SUNLIGHT HOUSE
DESIGN AND ACCESS STATEMENT
OFFICE REFURBISHMENT
140958/LO/2024

This document is a follow up to the submitted Listed Building Application for the office refurbishment at Sunlight House, Manchester, M3 3HP.

This LBC application only relates to Floors 1 & 6, previously occupied areas, the proposal follows the same principles set out in the previous application for all other floors.

LEVEL 1
WALL BETWEEN UNIT AND RECEPTION

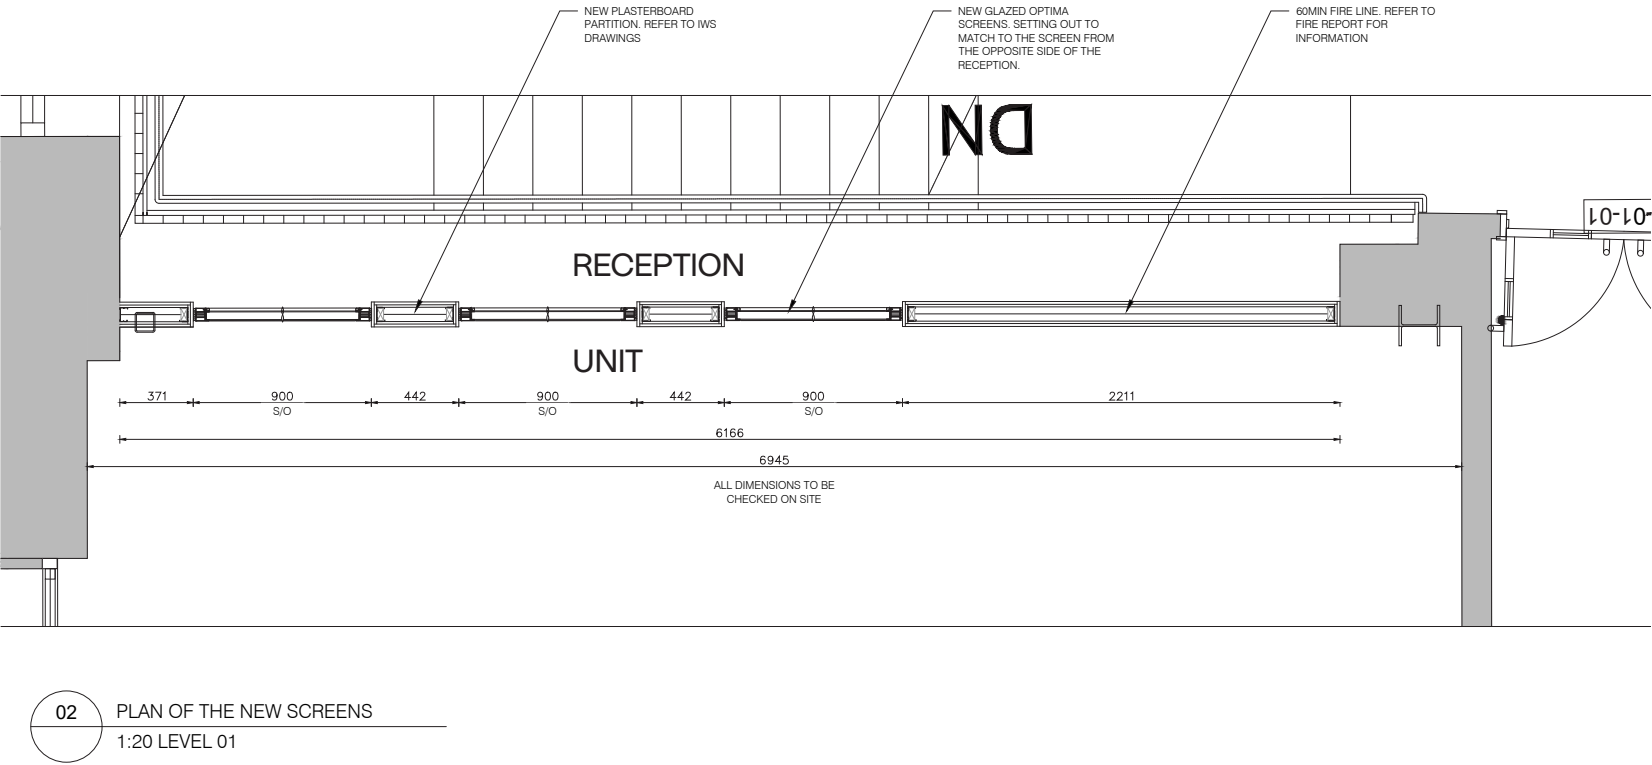
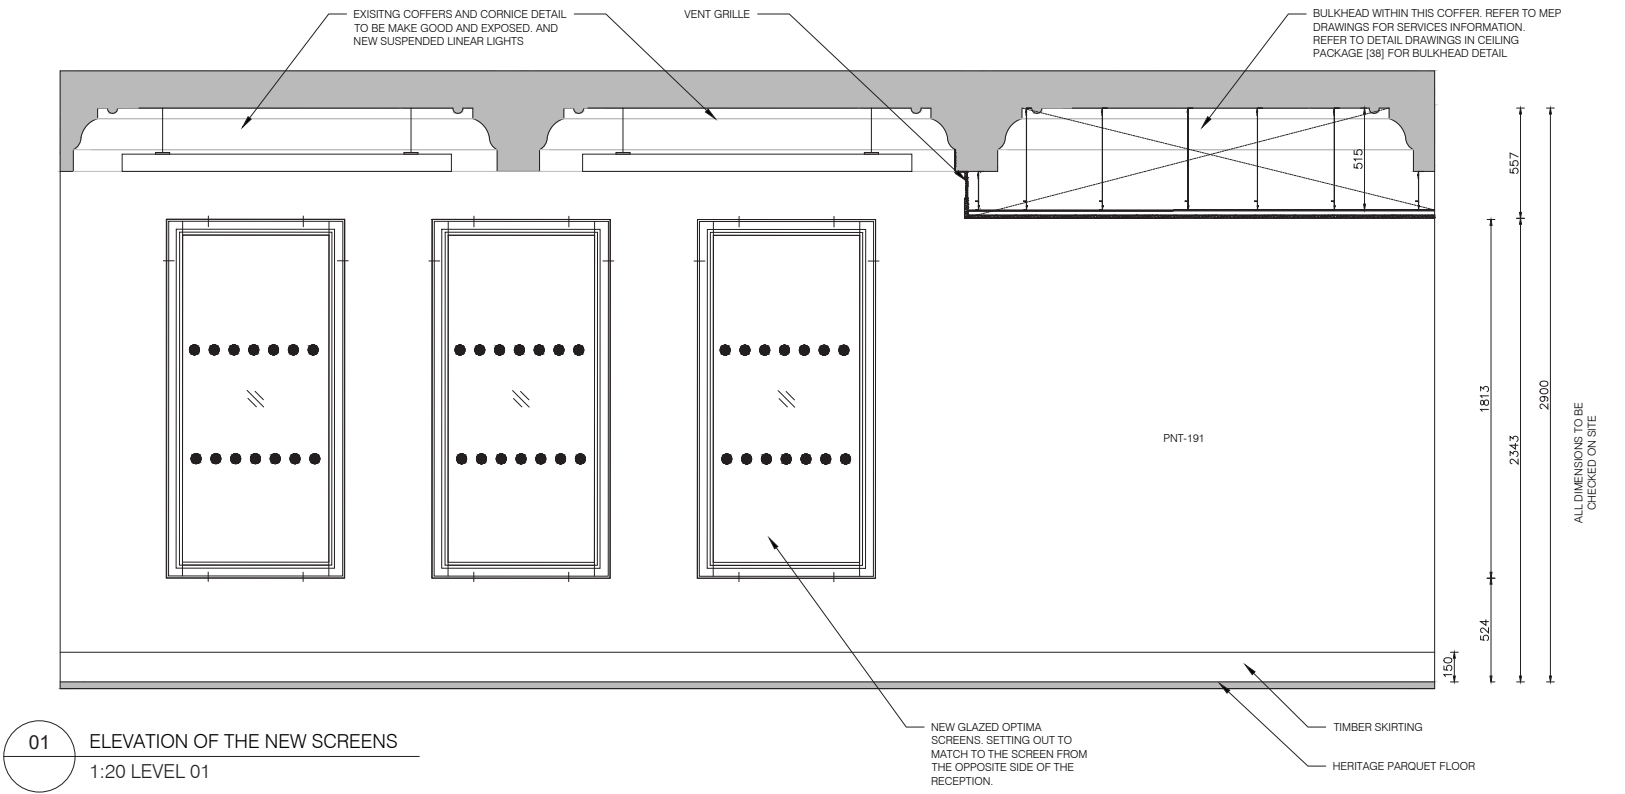
New plasterboard partition with three new glazed screens to match the condition from the opposite side of the reception.

LEVEL 6 GA PLAN

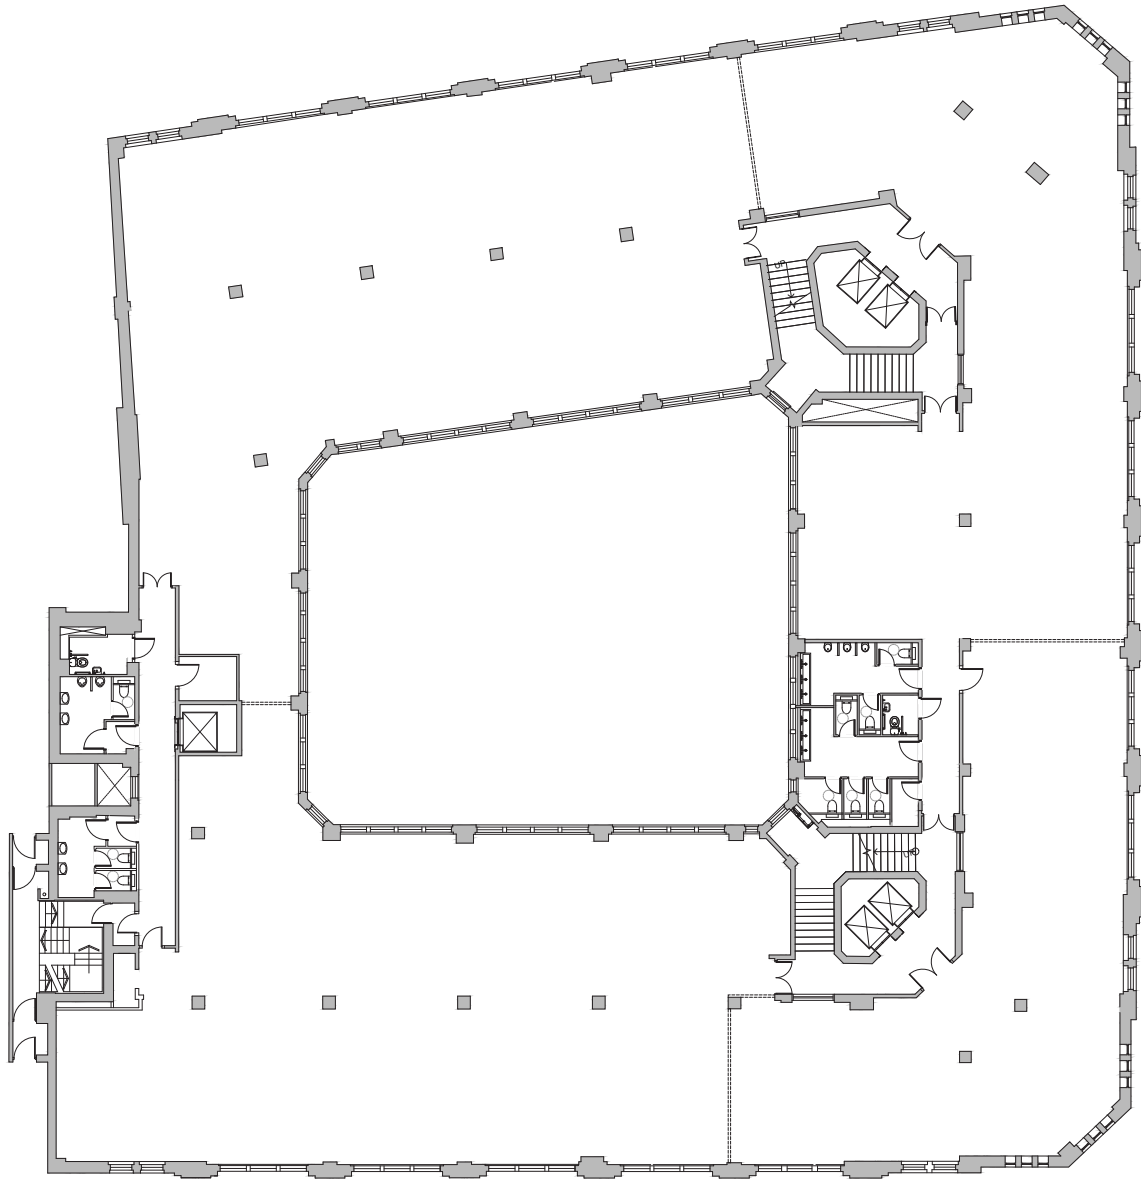
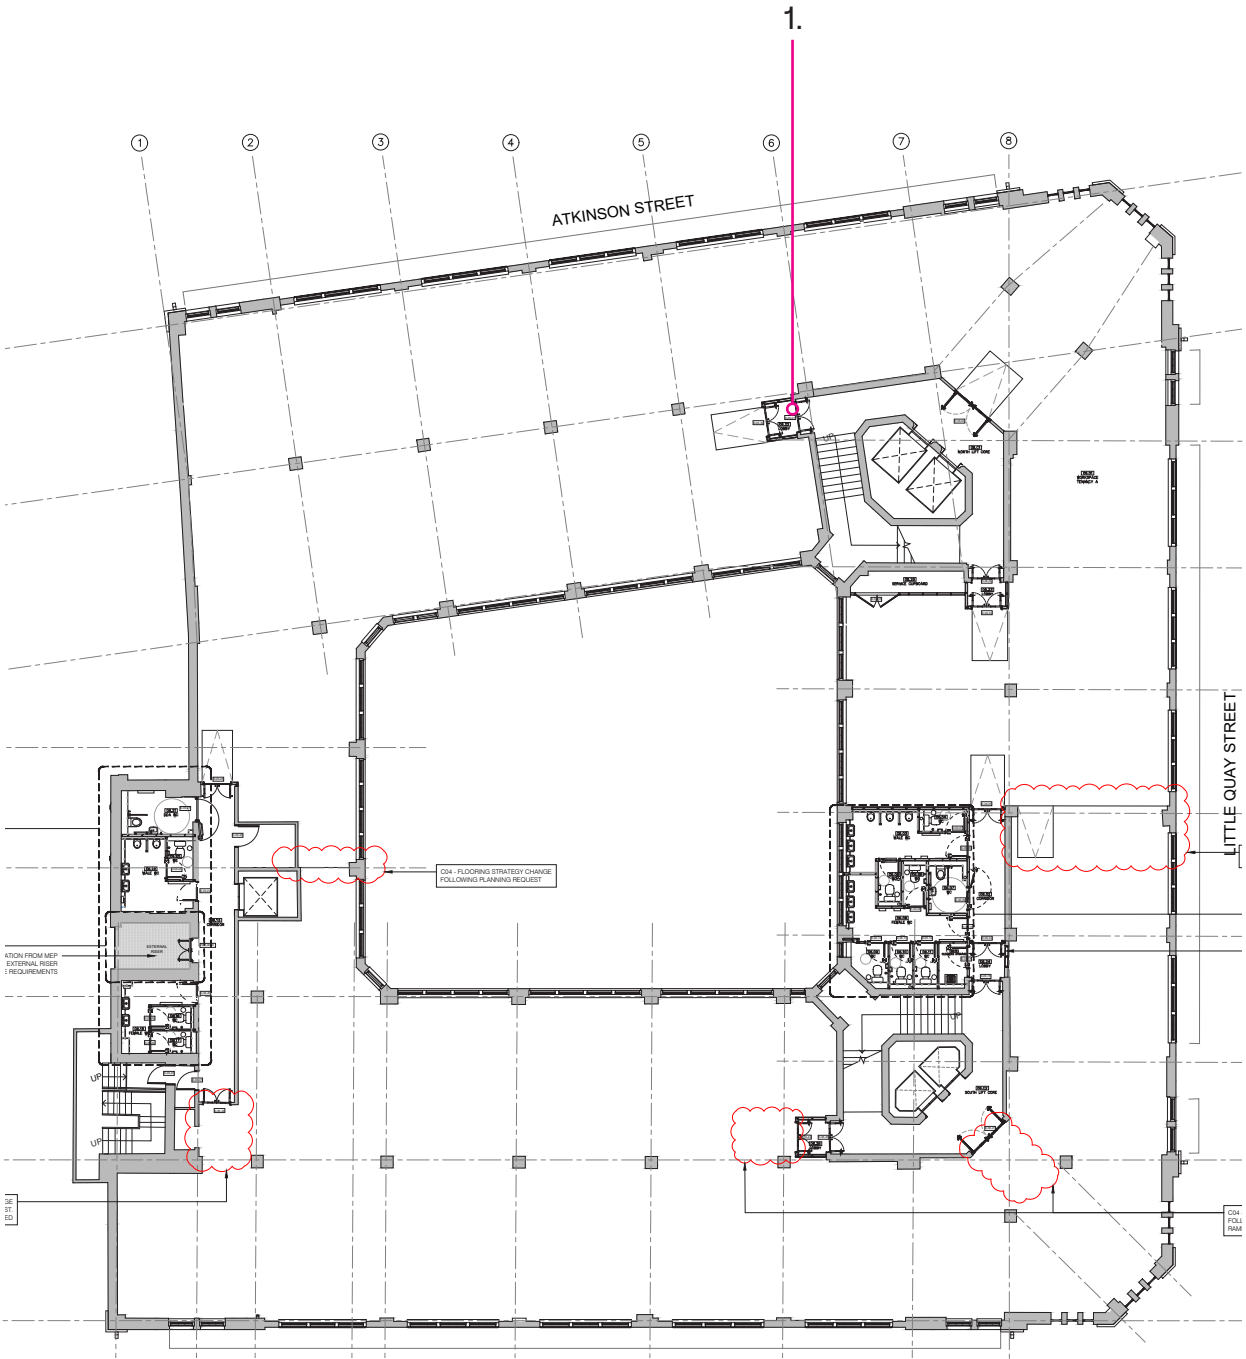
- 1. Small lobbies between the Core staircase and office floor following Fire strategy requirements.

LEVEL 6 GA RCP

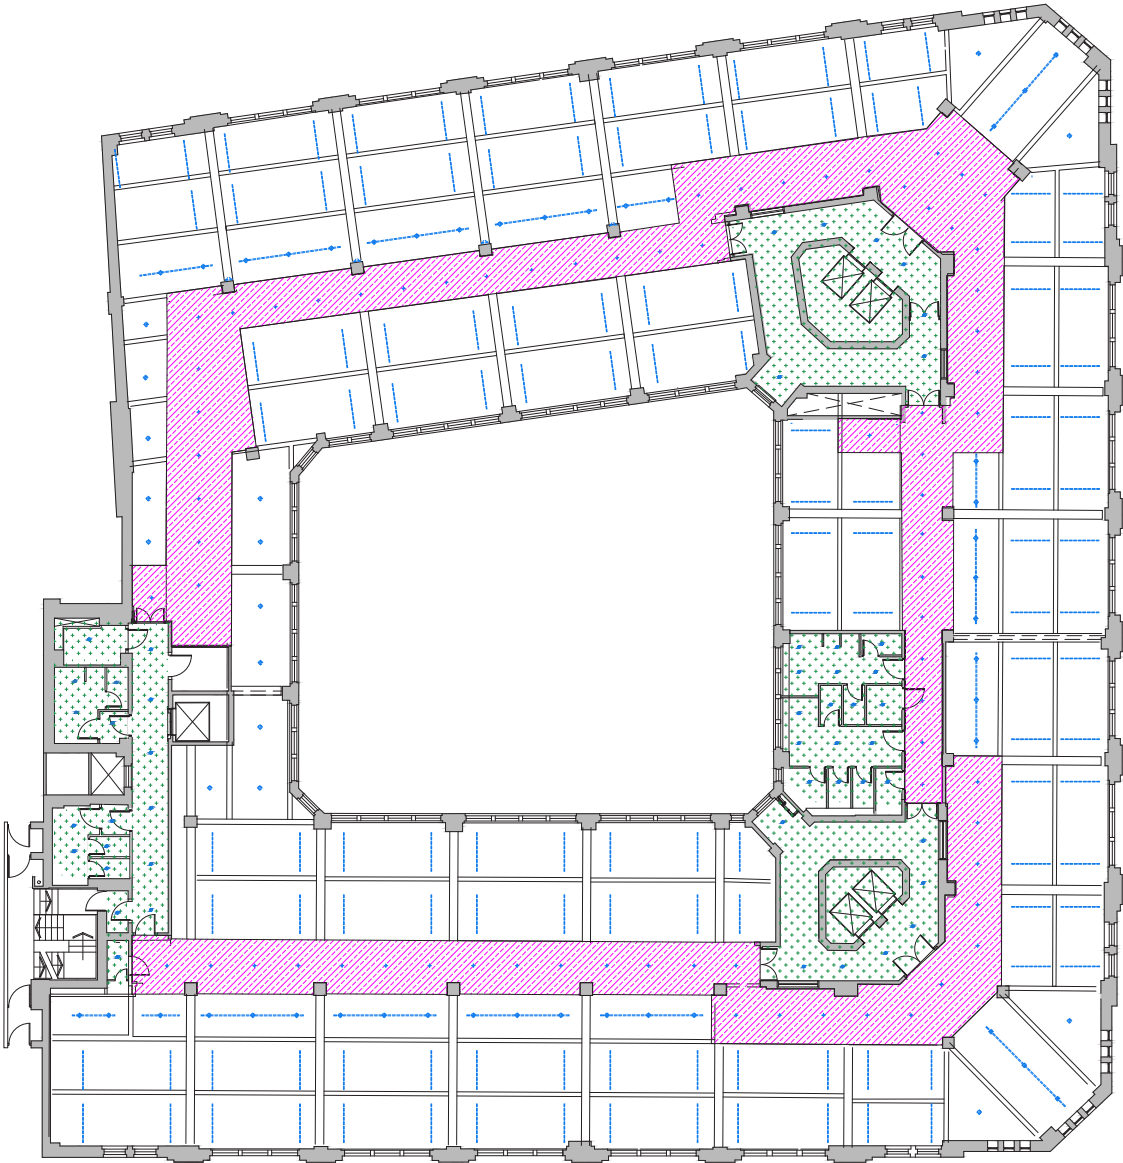
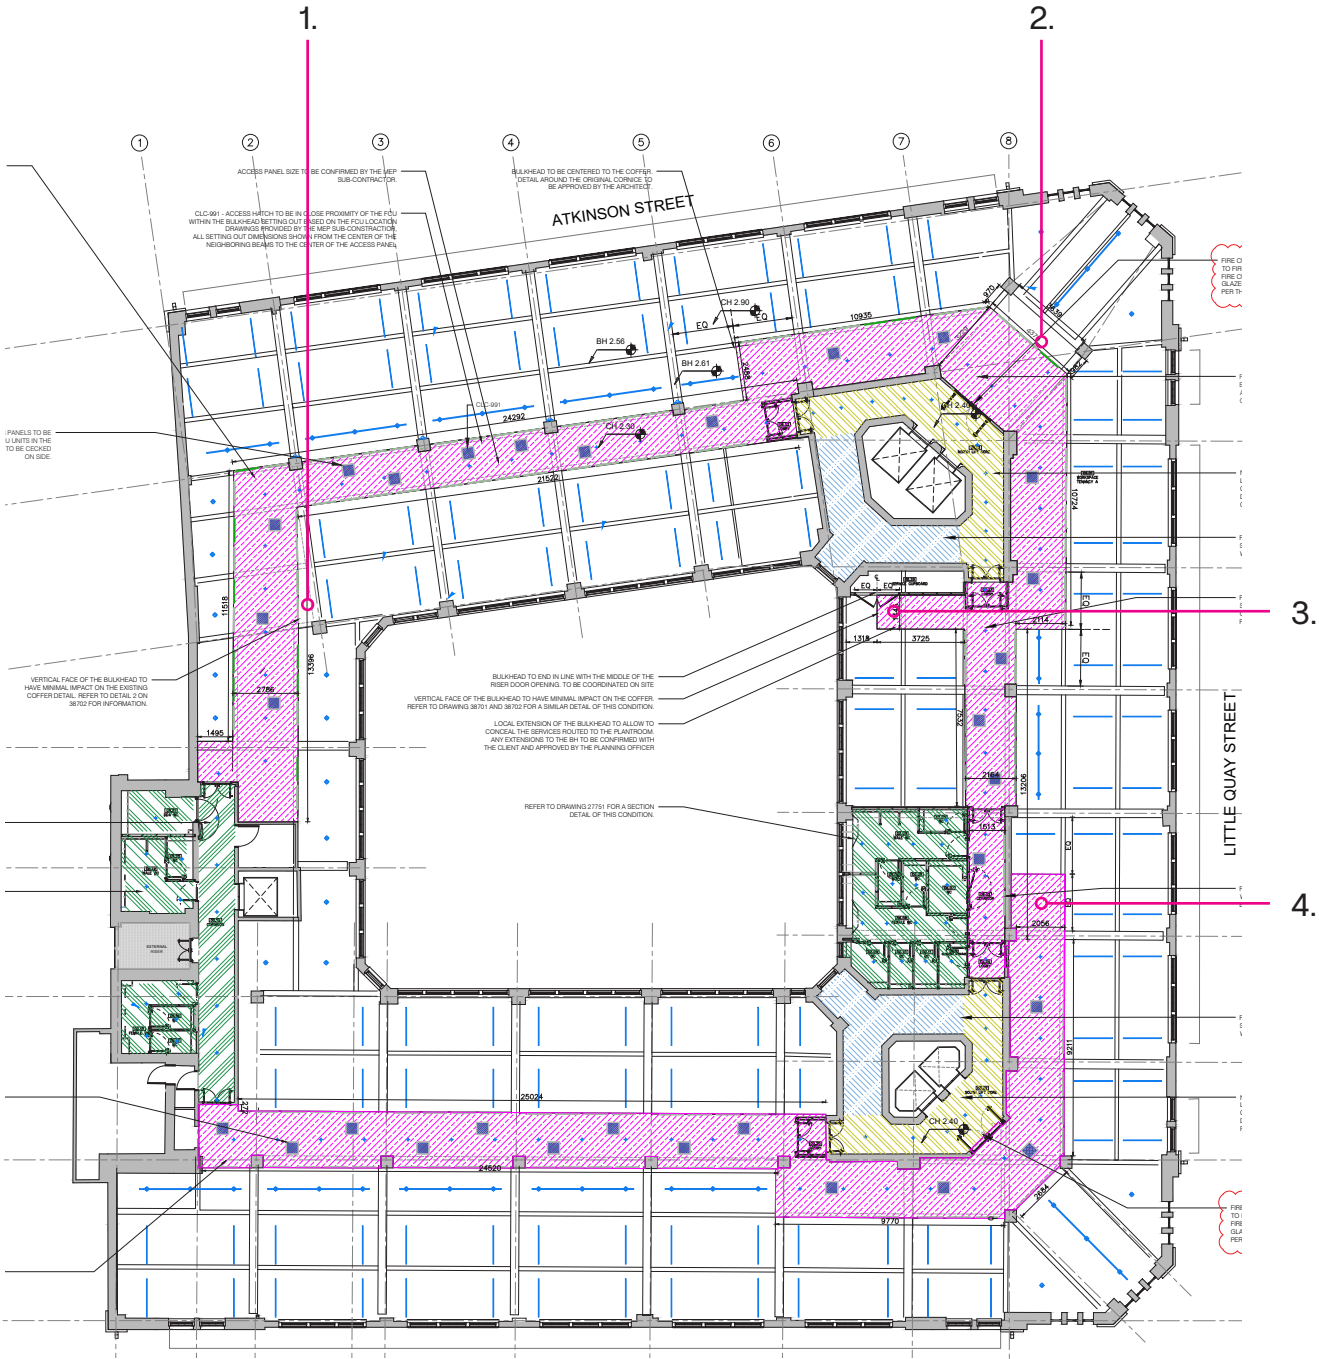
- 1. Bulkhead line simplified in this area since the original proposal was submitted
- 2. Bulkhead reduced in front of the North Core
- 3. Bulkhead slightly increased in front of the FOH riser door to allow for service routes. This has been discussed as part of 136161LO 2023 LBC condition.
- 4. Bulkhead slightly extended in front of the FOH riser door to allow for service routes. This has been discussed as part of 136161LO 2023 LBC condition.
